Fwd: Comments re: MMC 22 Bramhall site plan

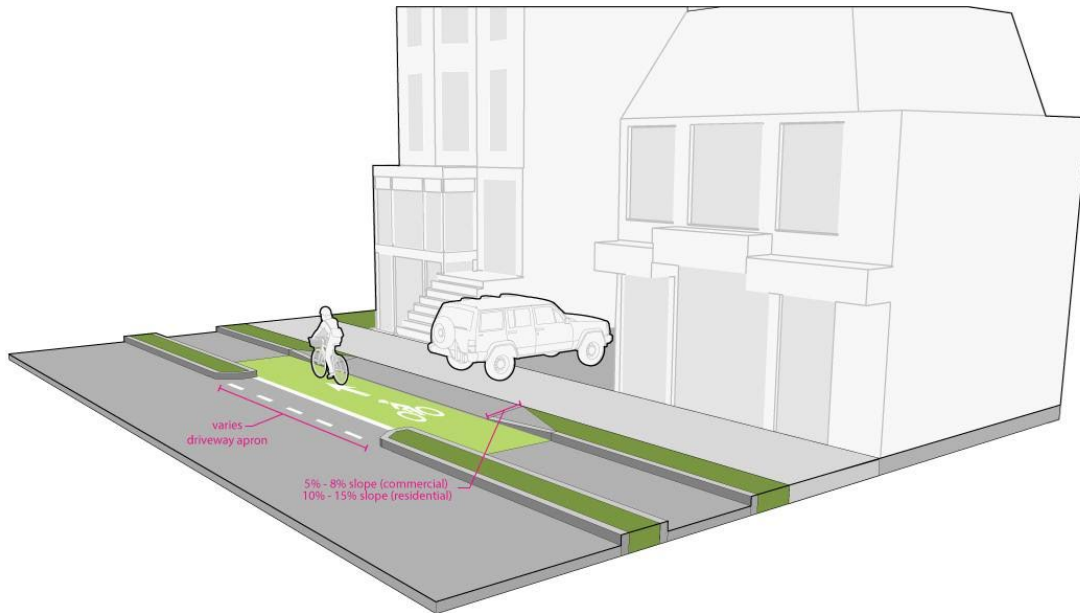
In those driveway crossings, I'd like to suggest the city and the applicant look into using high-visibility conflict zone markings, similar to markings that have been installed on Park Avenue, at the Exit 6 ramps and on Commercial Street at the Beach Street intersection (this image is from the [City of Seattle's Right-of-Way Improvements Manual](#)):
